Re: Cherokee Nation WW Hastings Replacement Hospital - Addendum 02 Narrative

Following is a list of revisions included in Addendum 02.

PROJECT PHASE:
BID PACKAGE 02
(SITE DEMOLITION AND UTILITIES)

11/18/2022 A:\2021\512321\03_DSGN01_DWG\050_CIVIL\07-WATR-5123.DWG

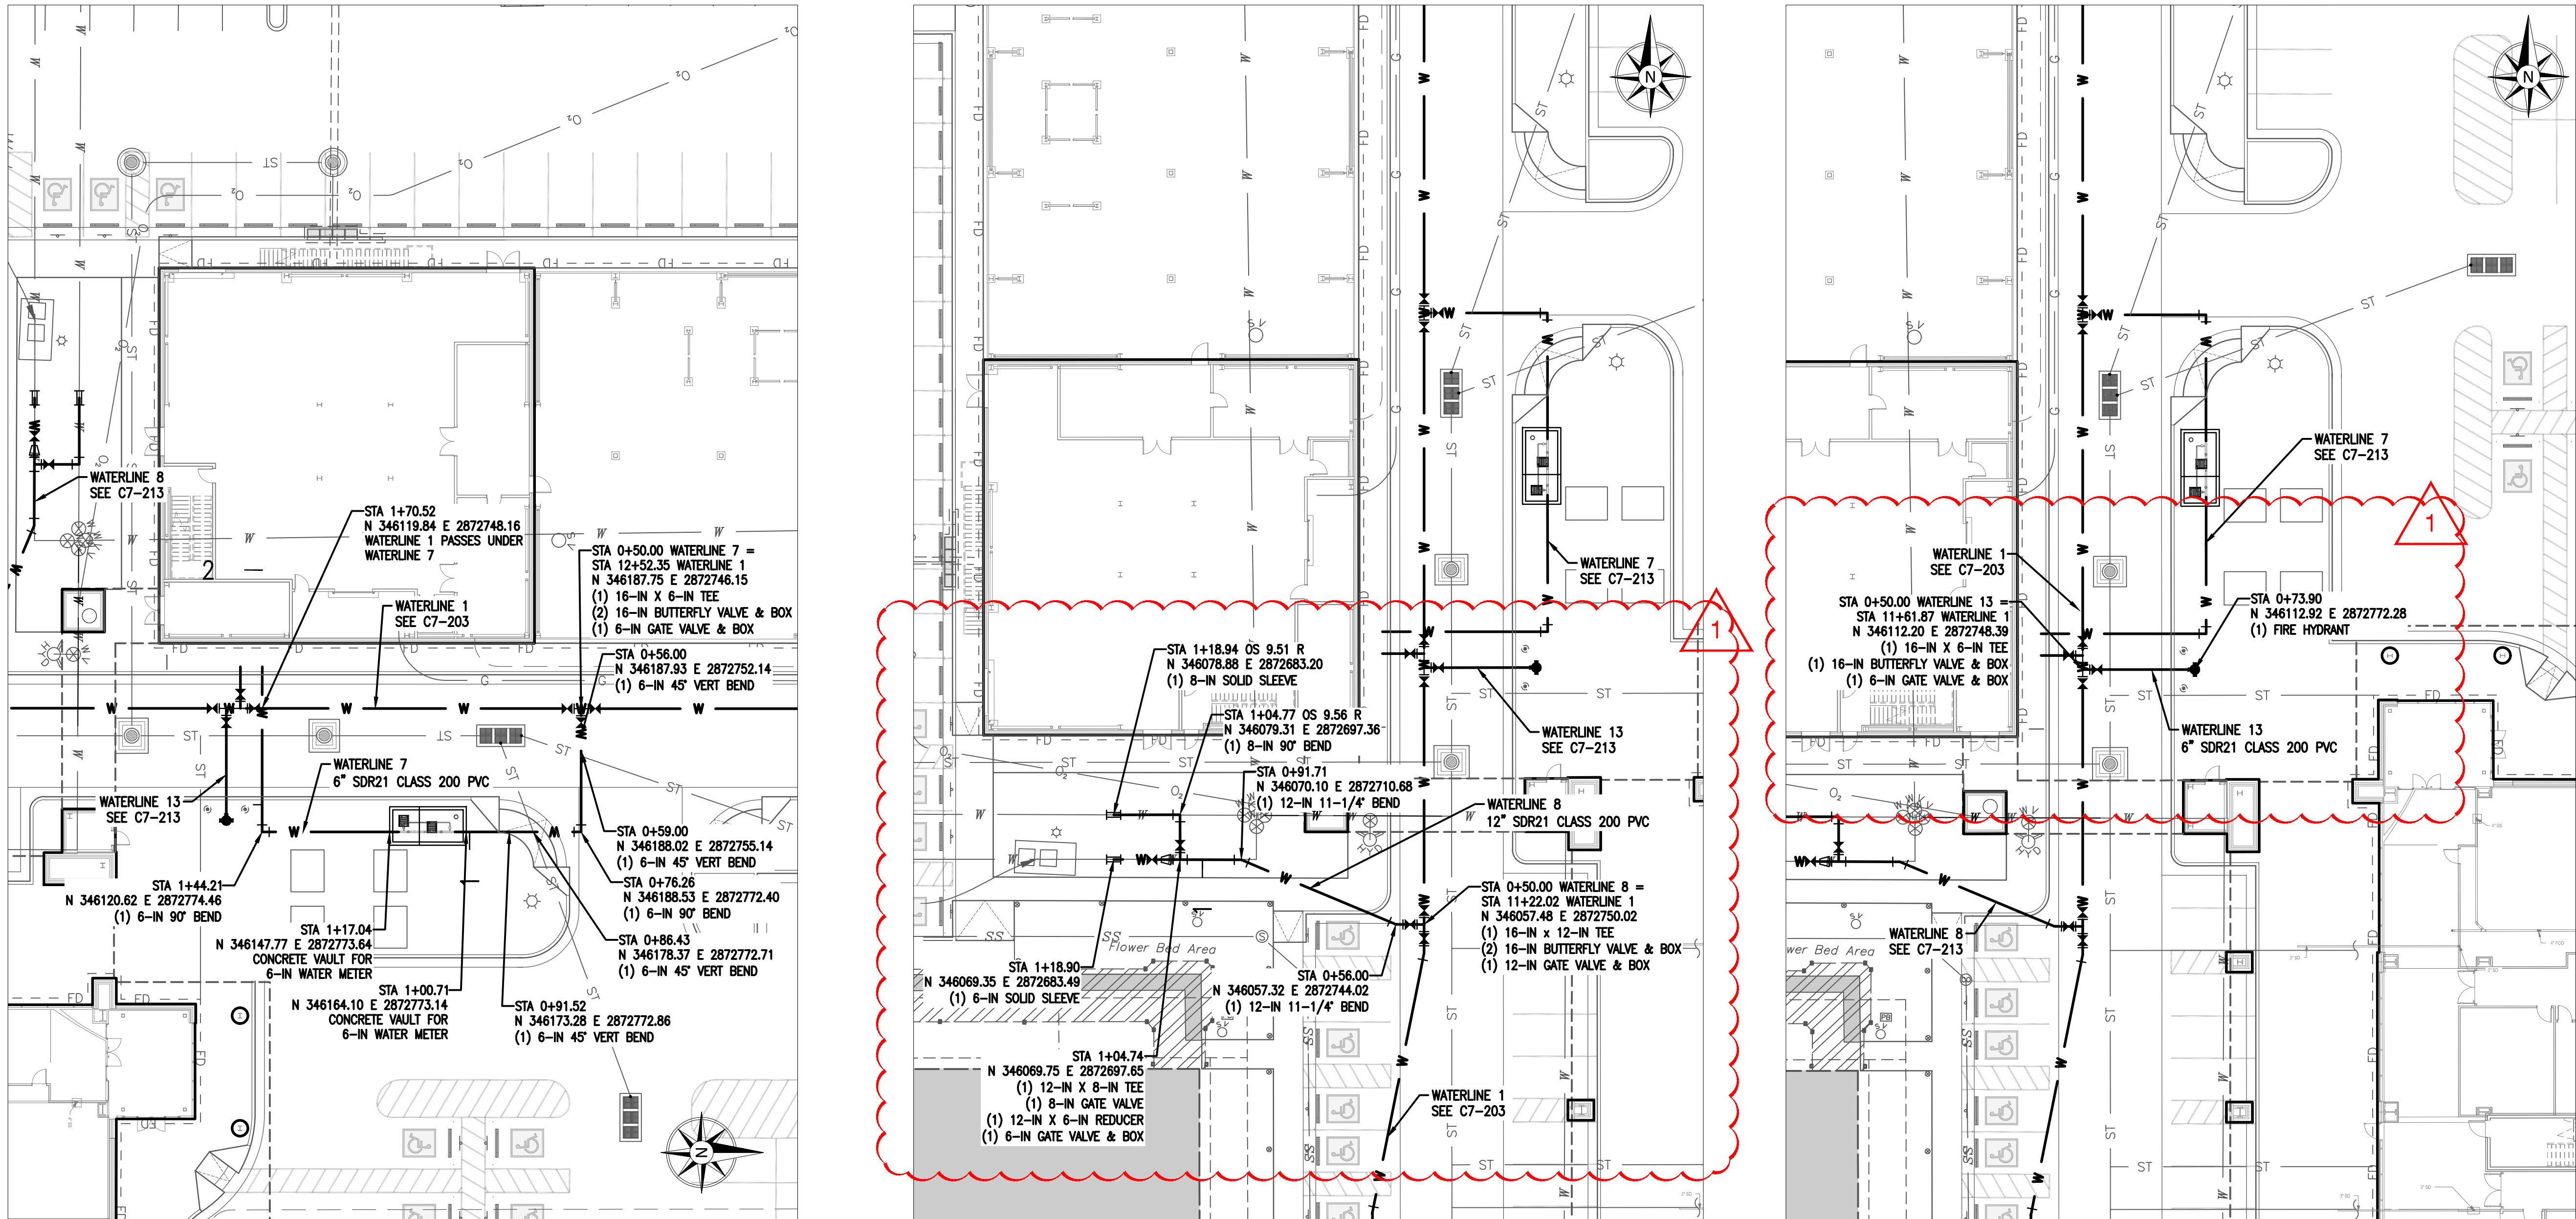
- C7-212 - Added the graphical presentation of the gate valve and fire hydrant to the profile view.
- C7-213 - Added call-outs to the materials in the plan view of Water 8.
Revised the profile view of Water 8 to match the plan.
Added labels to the plan view of Water 13.

C7-214

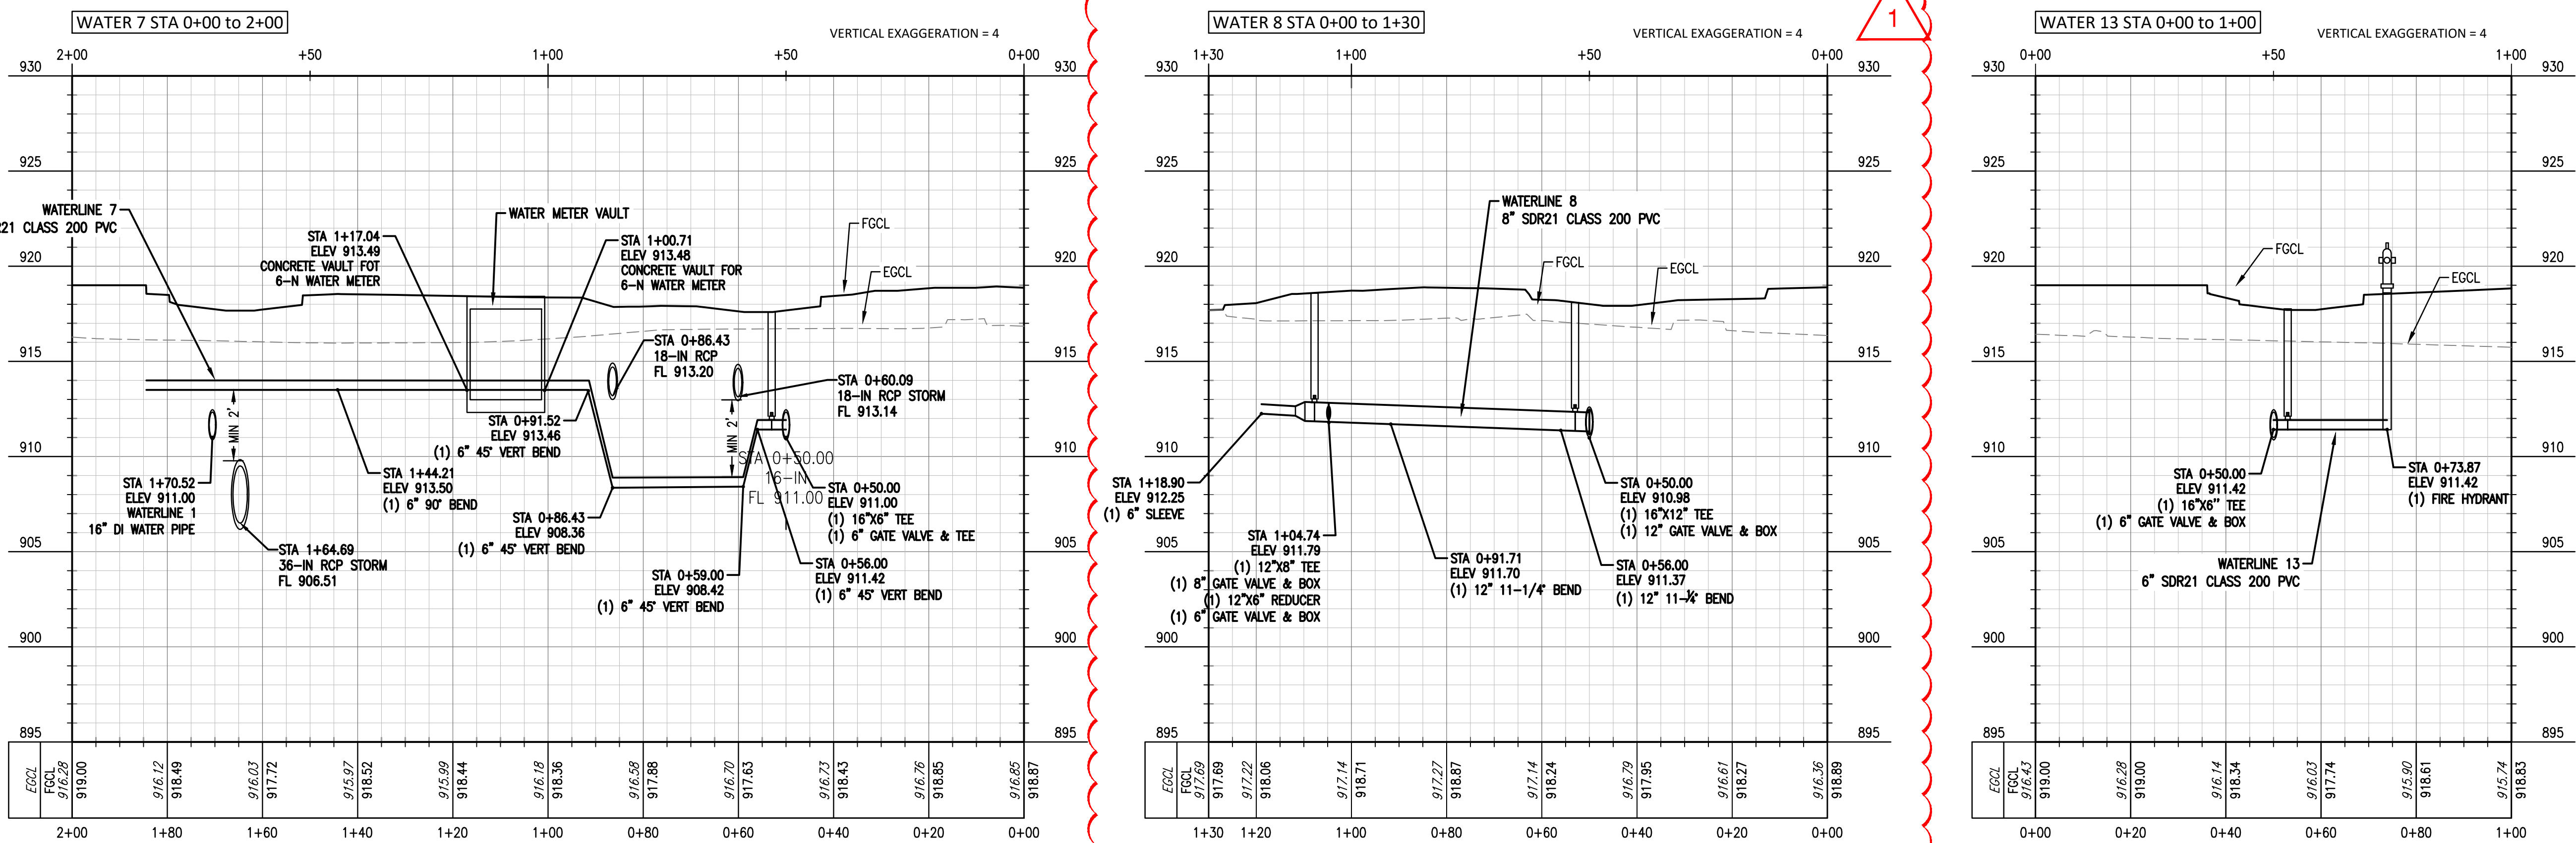
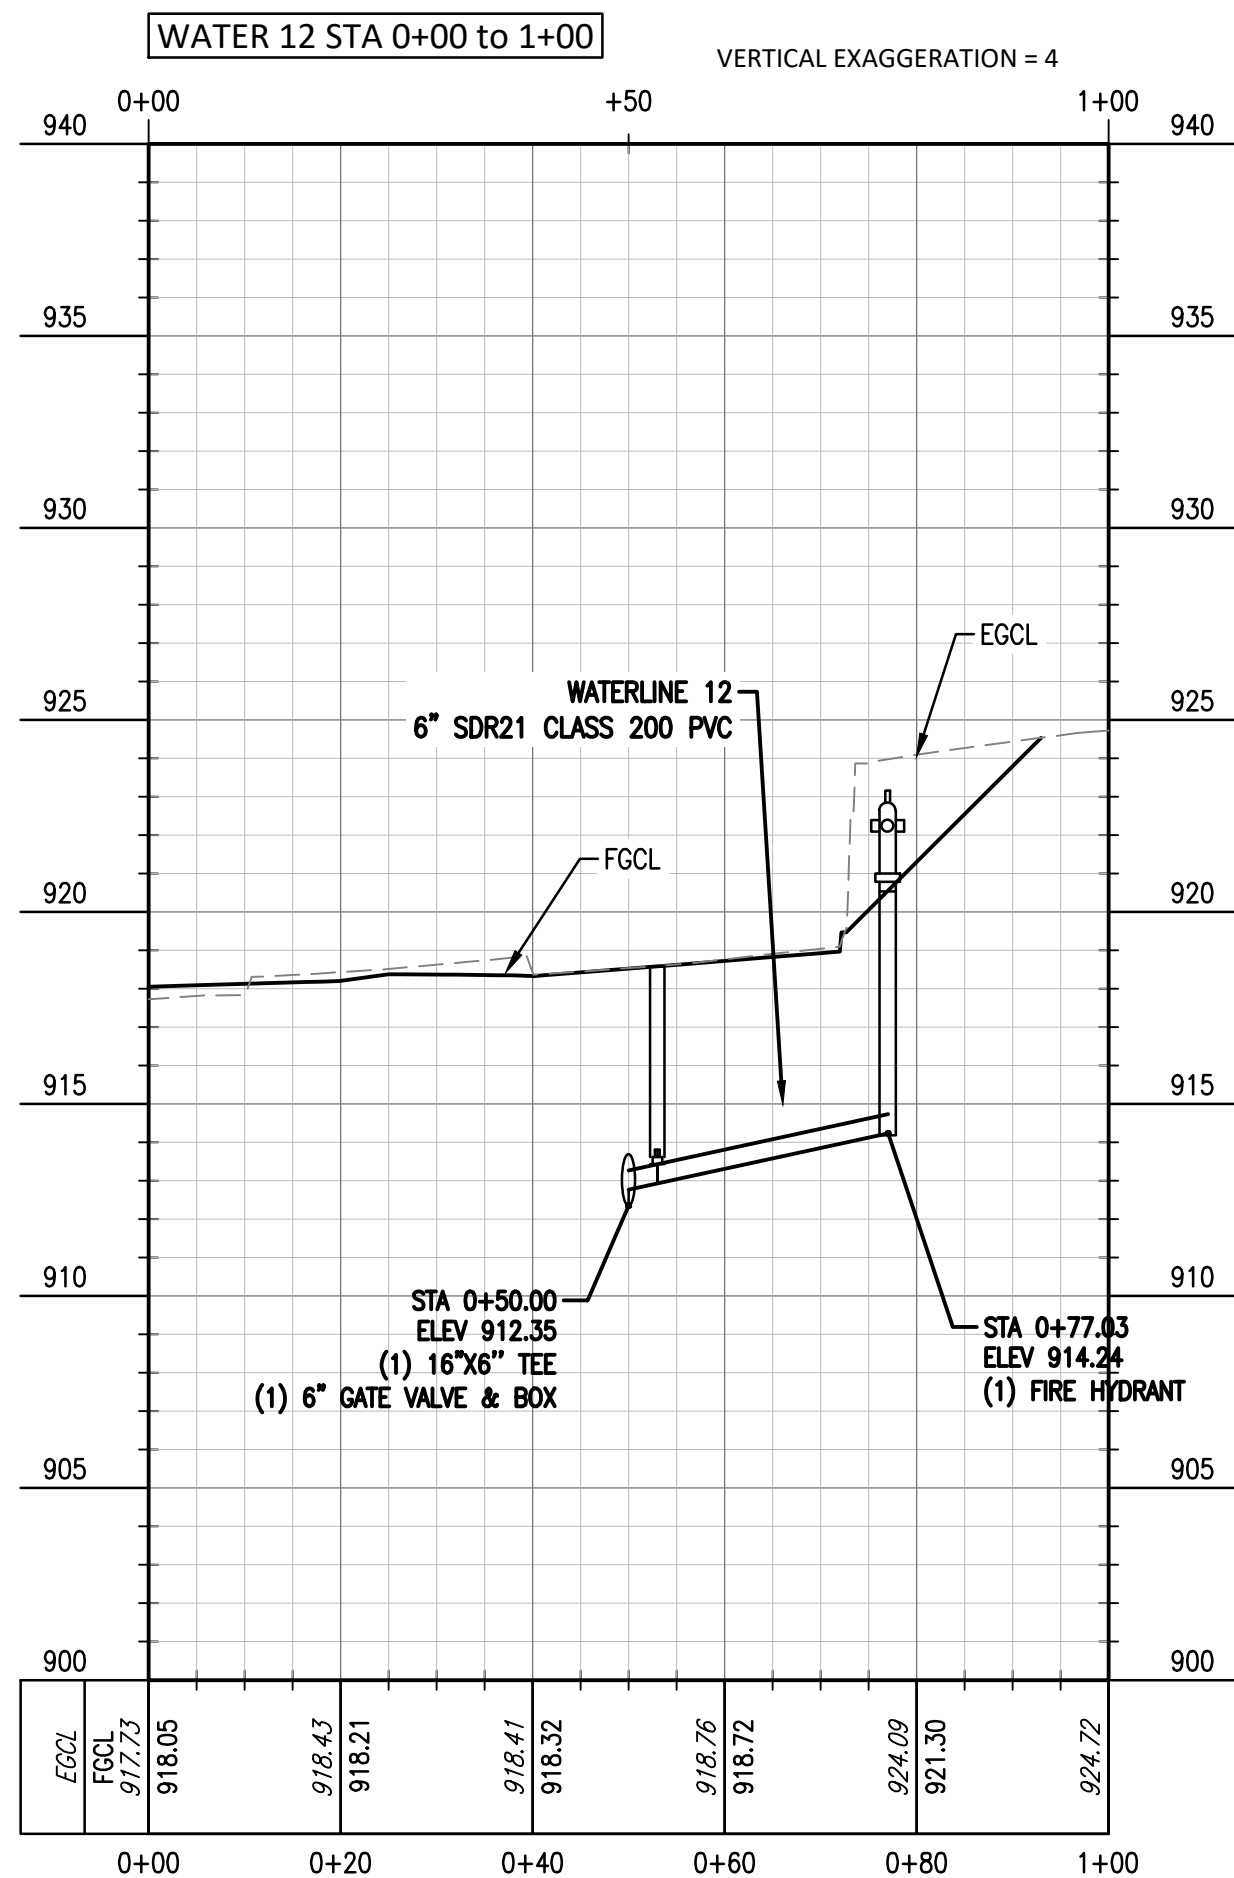
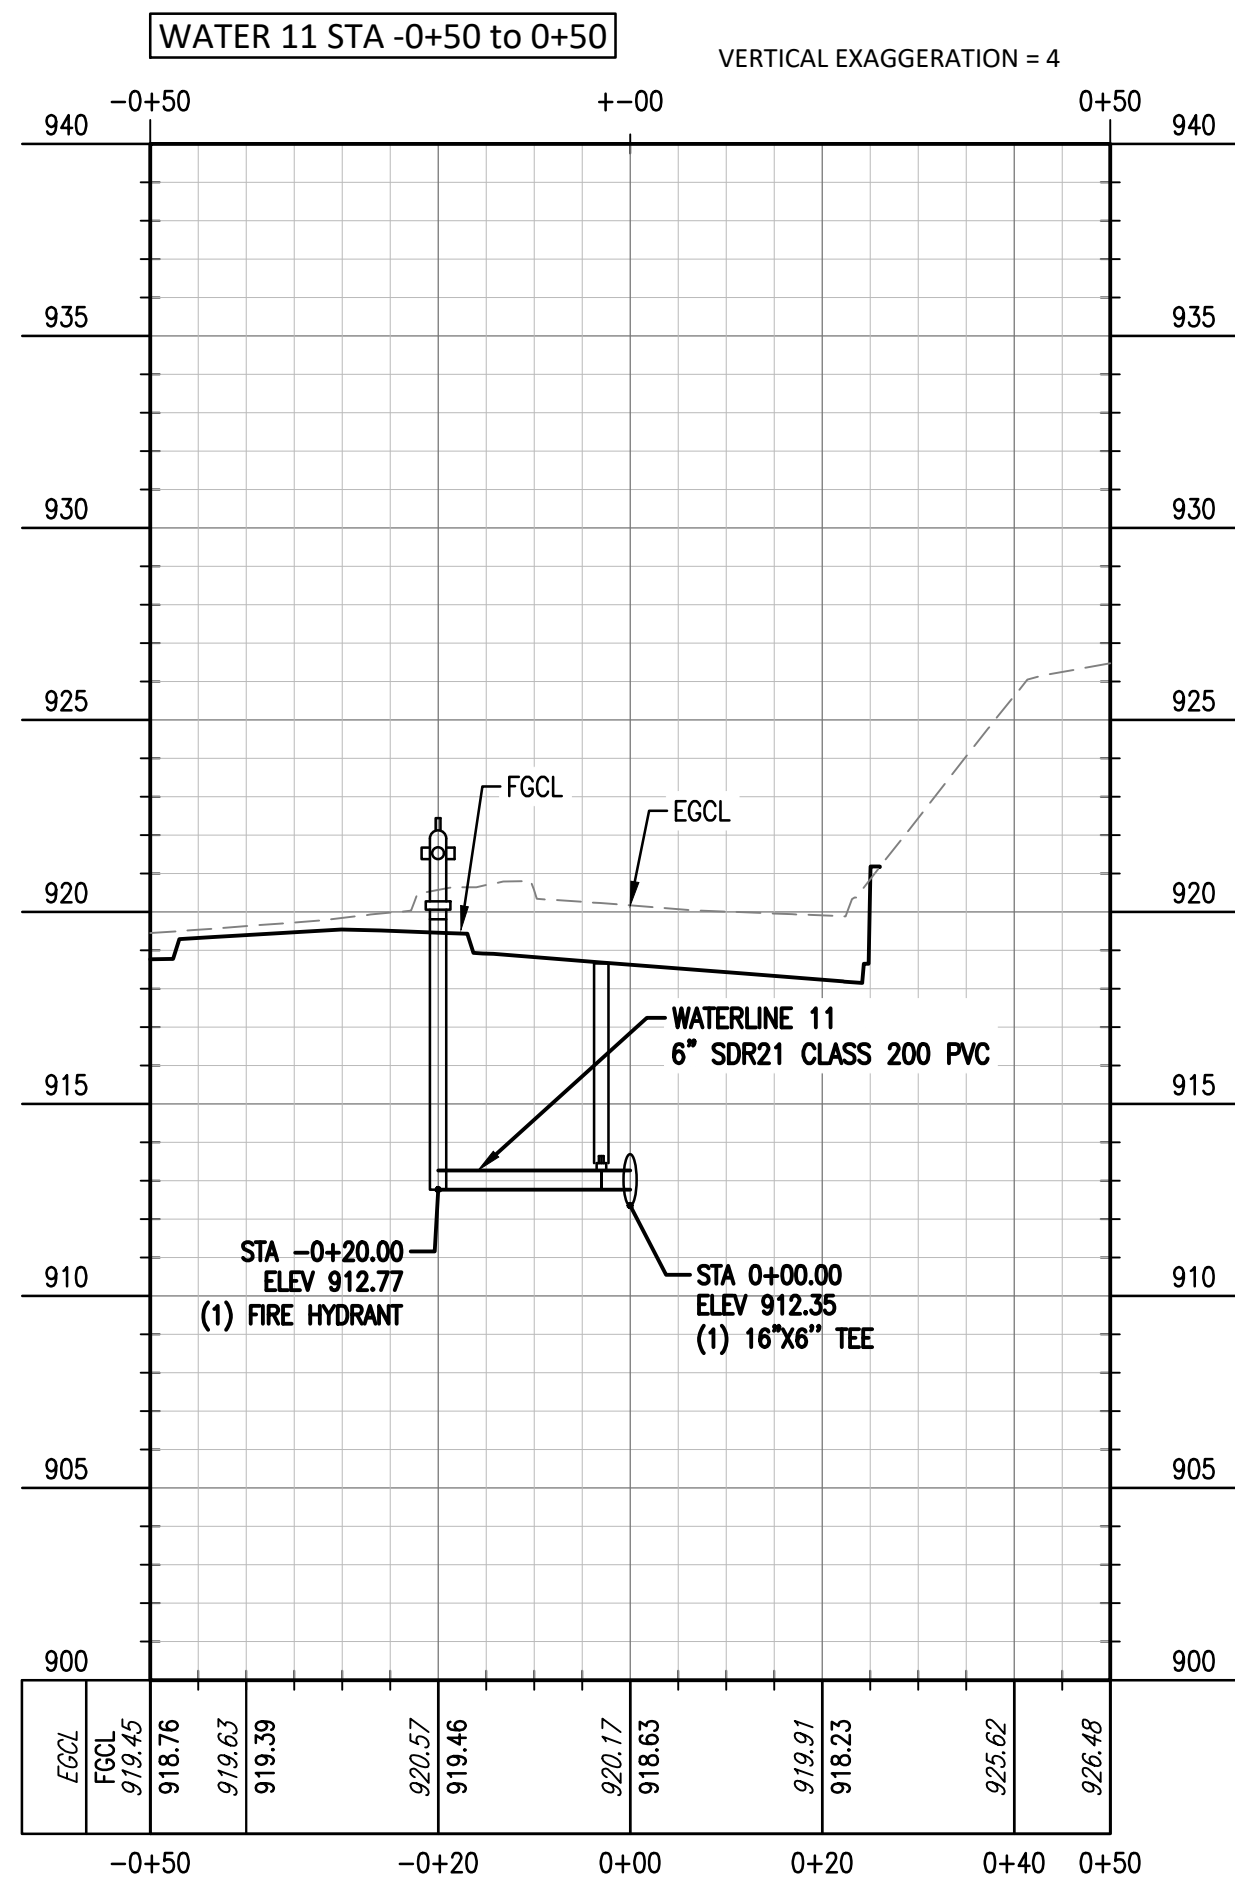
- C7-214 - Added call-outs to the material in the plan view of Water 12.
